1957 AMC-Hudson

Body Group &
Groups 1.000 thru 13.000

1957 - Body Section

"RAMBLER" SERIES GRILLE REMOVAL

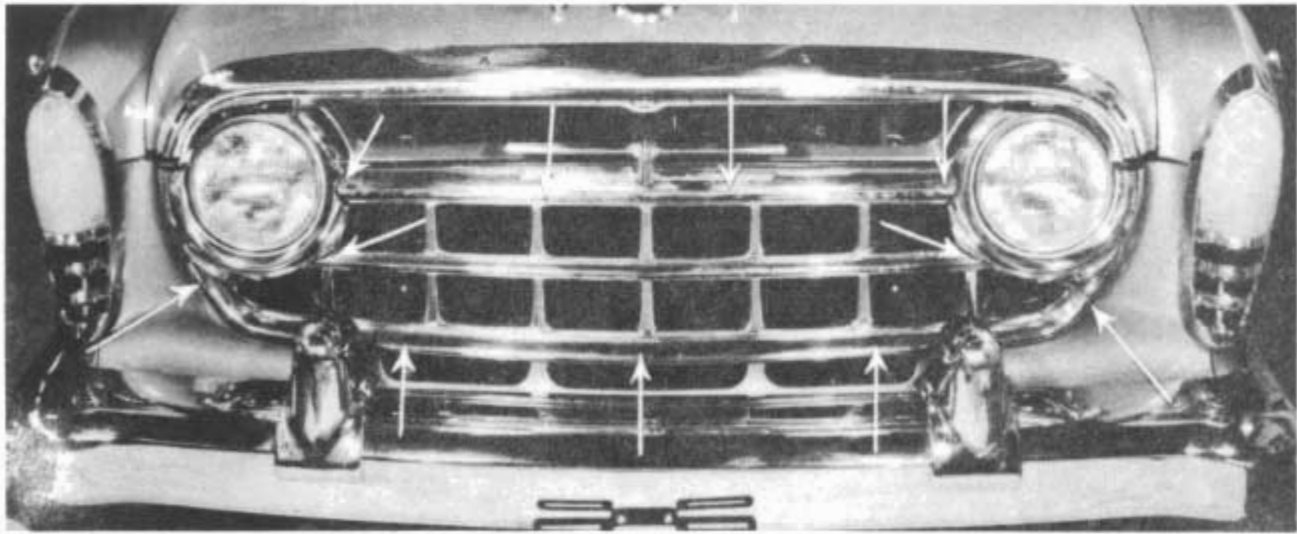
Remove the headlamp assembly without disconnecting the wire harness. Place and tape them to the radiator cross tie plate or upper baffle.

Remove the nuts and washer from the studs on each end of the grille bars through the headlamp openings.

Remove the other five nuts through the grille openings with a 7/16" midget socket and ratchet.

American Motors Technical Service Att. #57-18 illustrates the grille mounting stud locations.

Arrows indicate location of nuts and washers
to be removed from grille anchoring studs.

American Motors
Technical Service Att. #57-11
Printed in U.S.A.

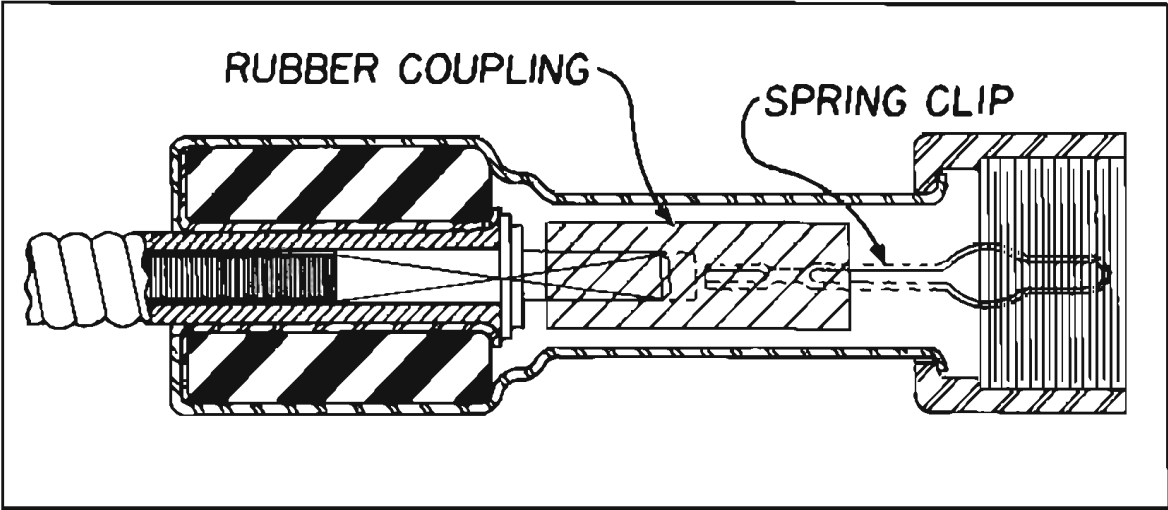
American Motors Technical Service Att. #57-11 illustrates the speedometer cable rubber coupling and spring connector used on all 1957 Series.

The elimination or damage to this rubber coupling (insulator) will result in erratic or no speedometer action or speedometer cable noise.

CHANGE TO STRAIGHT DOWELS - FLYWHEEL TO TORUS COVER

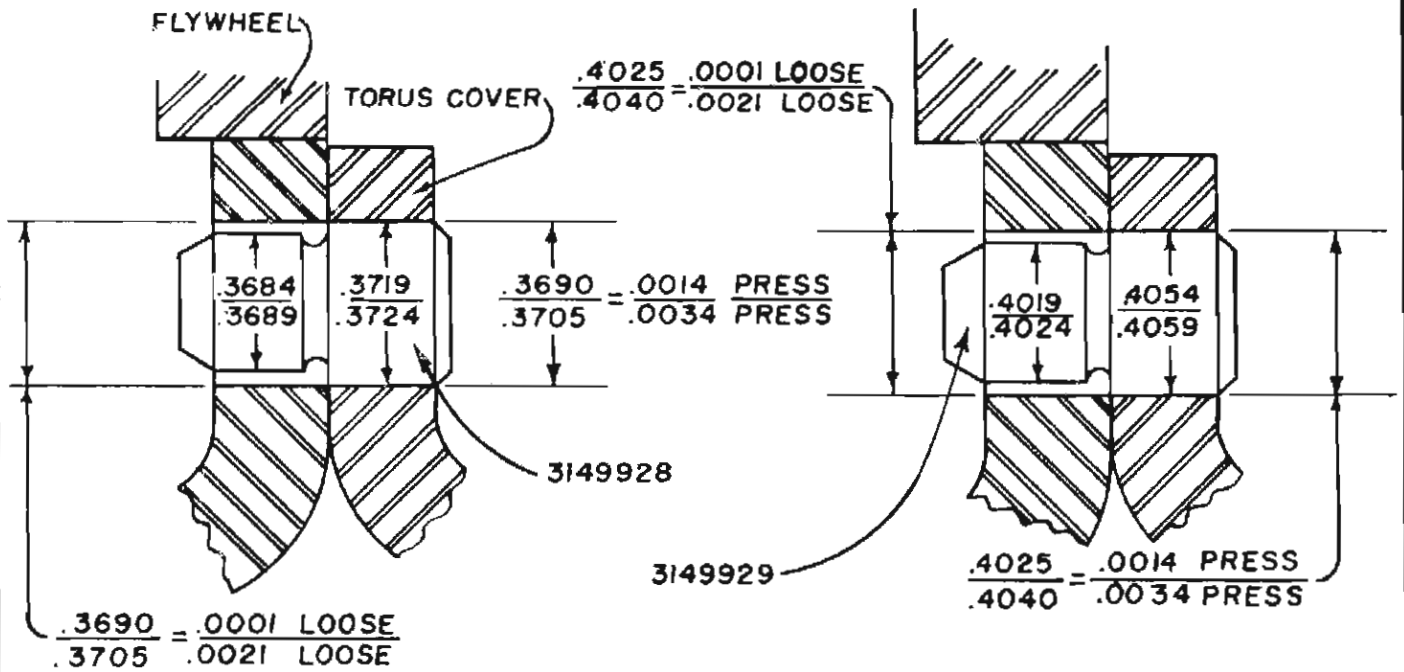
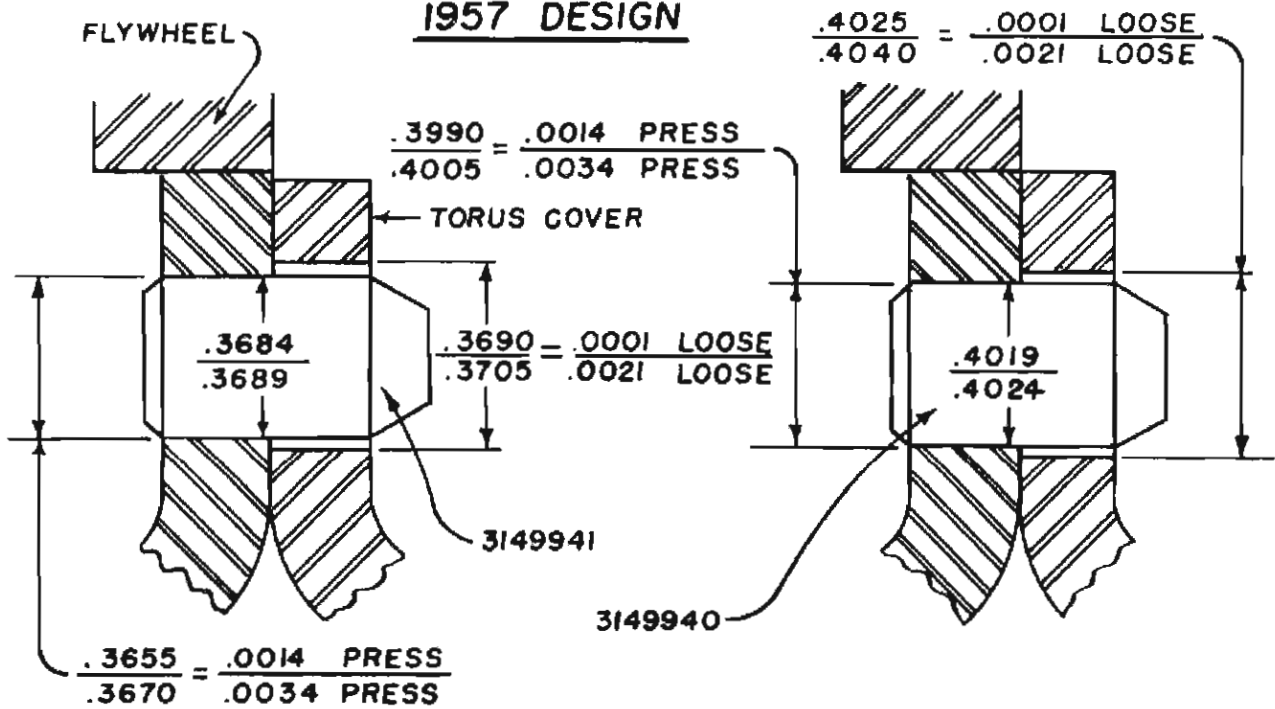
The 1957 service torus cover assembly and the flywheel assembly will conform to this change and will supersede the 1956 comparable service parts.

To provide complete interchangeability, two dowel pins will be serviced loose as part of the torus cover assembly service package.

When attaching a 1957 service flywheel to a 1956 torus cover, remove the two dowel pins from the original torus cover.

Additional Torus Drain Back Points Not Shown on Drawing

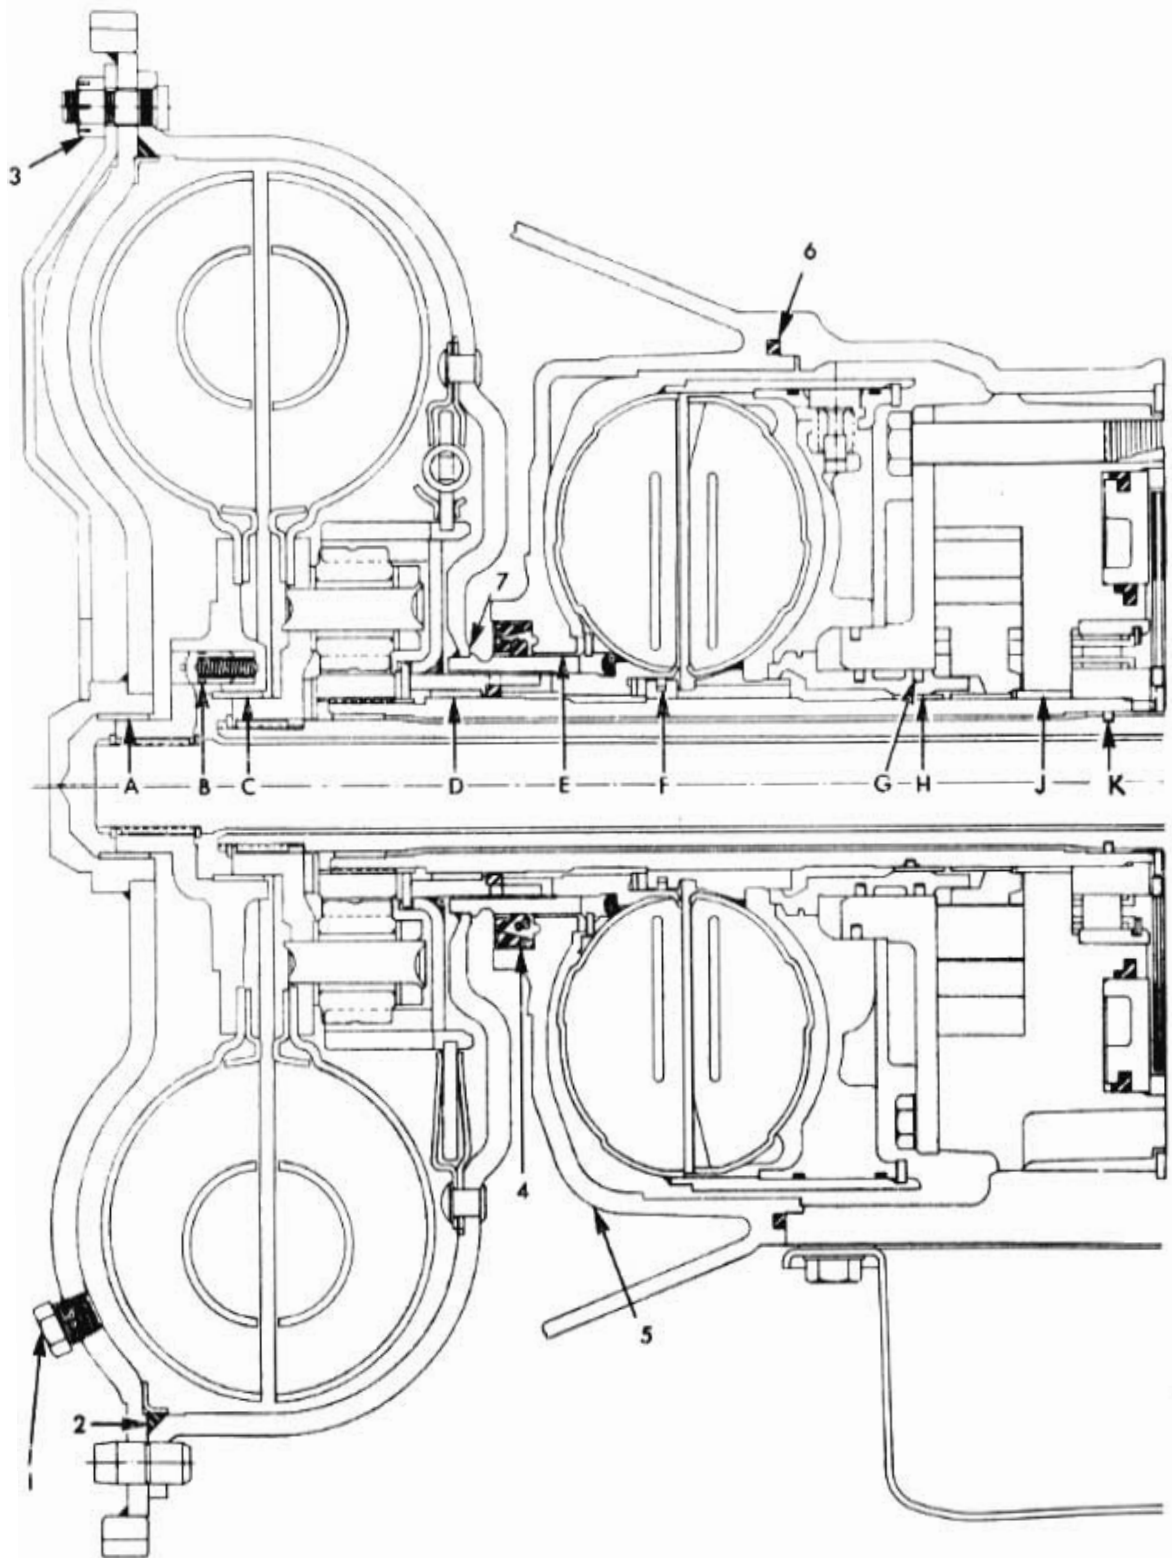
Oil Seals - Cooler Sleeve Front Pump

Inspect these seals to make certain they are not damaged and are correctly positioned.

IDENTIFICATION OF SPACER CHANNEL PLATE TO CASE

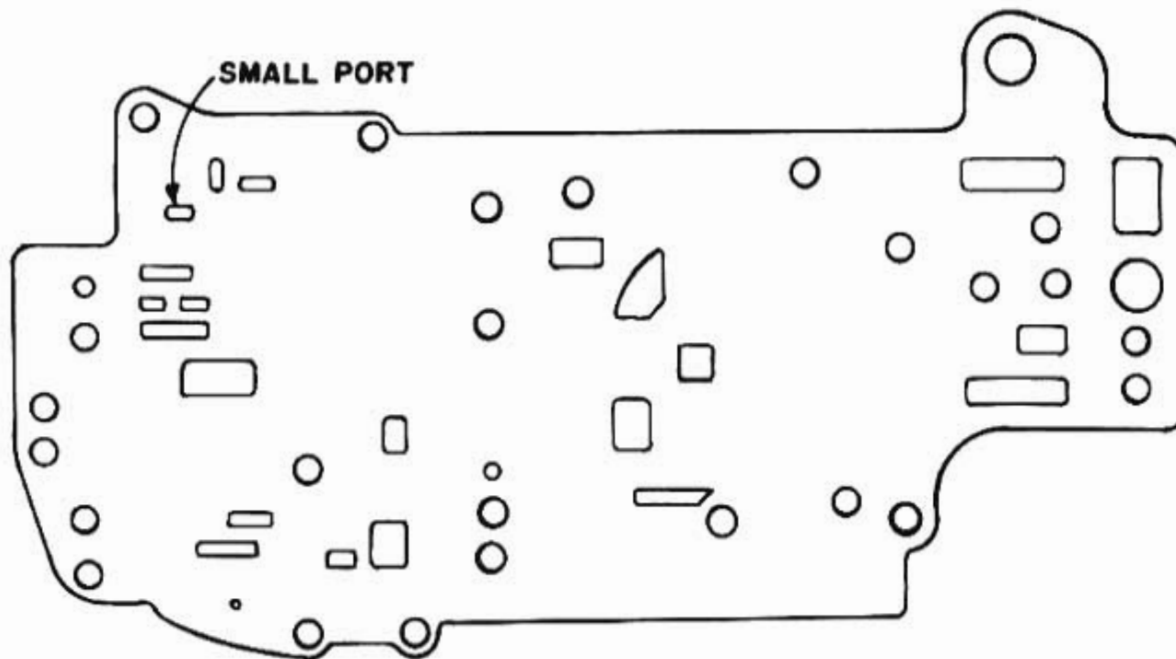
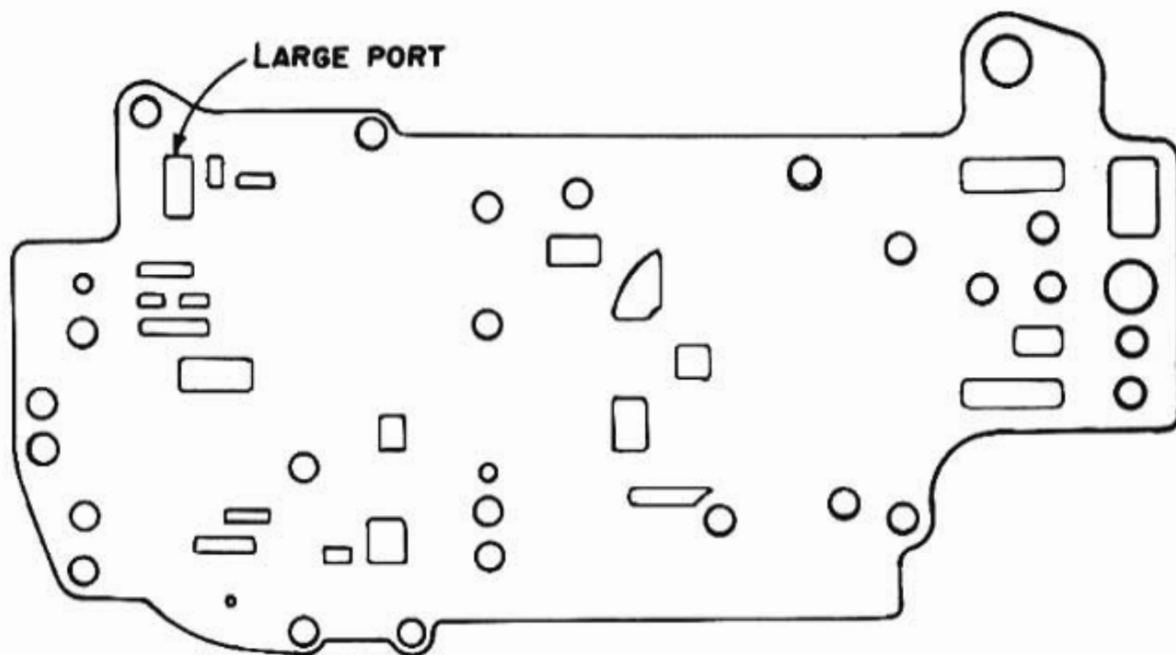
The 1957 Flashaway Transmission Manual Valve Body, Part Number 3200440, has been revised to provide additional exhaust for neutral clutch apply oil in "Reverse".

Only the revised Manual Valve Body and Spacer will be available for service replacement.

The new spacer may be used with either the early or the revised Manual Valve Body Assembly. However, installation of the revised Manual Valve Body requires the use of the new spacer.

The use of the old style spacer with the revised Manual Valve Body Assembly will allow excessive IILII range oil leakage at the Manual Valve Body. The resultant insufficient IIL" range oil pressure could cause low band failure.

American Motors Technical Service Att. #57-10 will enable proper identification of the two spacers.

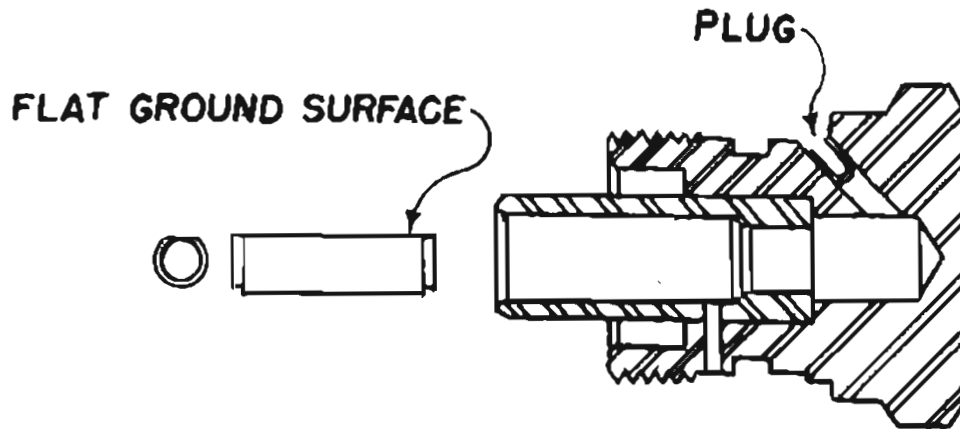
Part Number 3113569, Front Servo Booster Spring removed.
Part Number 3115513, Rear Servo Compensator Spring removed.
Part Number 3142216, T.V. Pressure Plug and Part Number 3142213,
Pressure Regulator Plug Assembly replaced by Part Number 3200450.

The T.V. Pressure Regulator Plug has a flat ground surface by removal of .025" from the diameter and the plug and sleeve assembly drilled T.V. pressure hole has been plugged as illustrated in American Motors Technical Service Att. #57-13.

STALL TEST

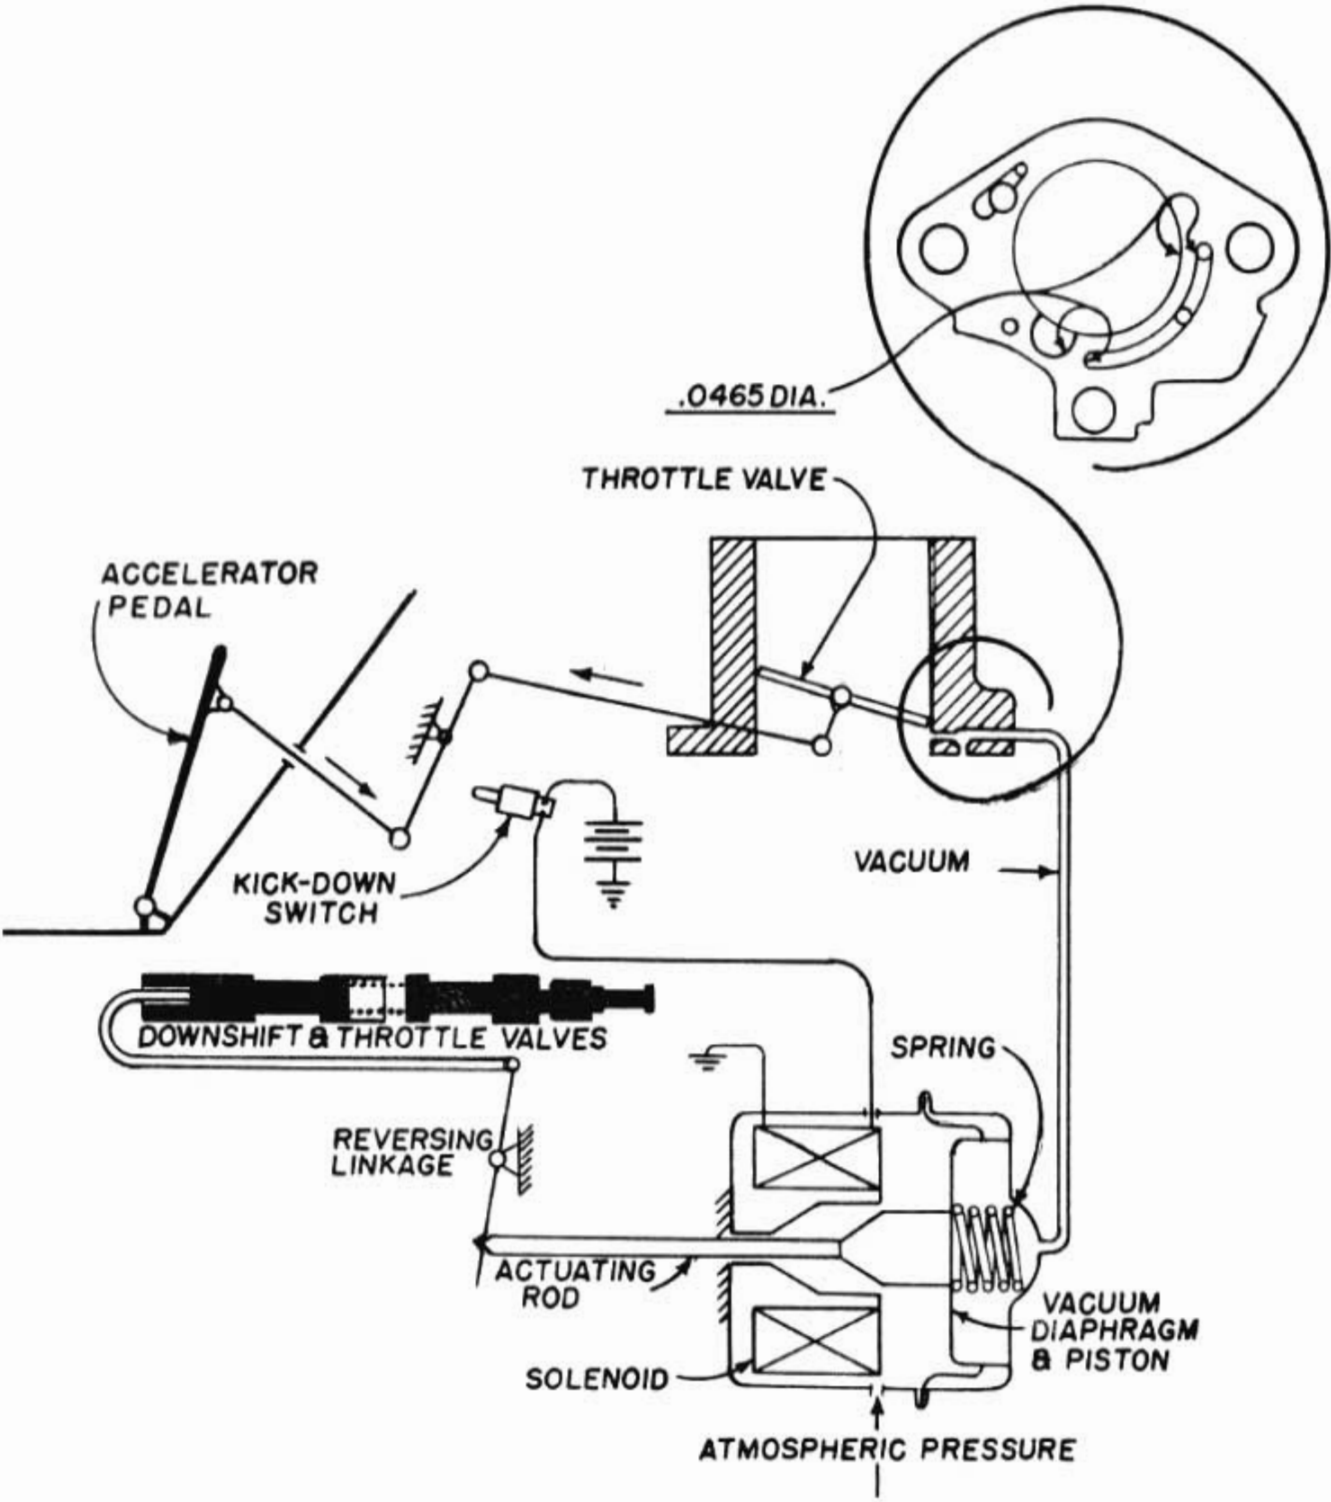
R.P.M.	1000
Transmission Vacuum	5.5" to 6.5"
Transmission Oil Pressure	80# to 90#

Transmission vacuum in excess of 6-1/2" at 1000 RPM indicates an unbalanced vacuum source from leaks, obstructions, or carburetor vacuum calibration. Adjustment of the vacuum and solenoid control unit has no affect on transmission vacuum.

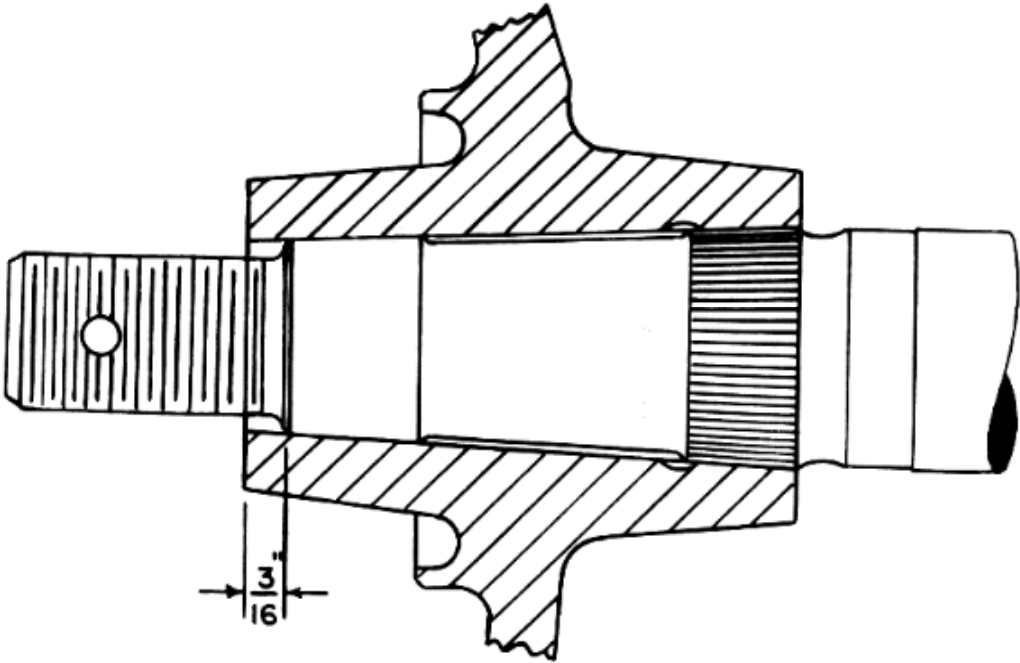
The hub is properly located when the measurement from the outside face of the hub to the taper of the axle shaft is $\frac{3}{16}$ " as shown in American Motors Technical Service Att. #57-17. Over-tightening beyond this dimension will cause interference between the drum and brake support plate.

This measurement also applies to a service replacement hub which is not serrated. The serrations will be cut in the hub when installed on the shaft. This is possible by the difference in hardness of the shaft and the hub.
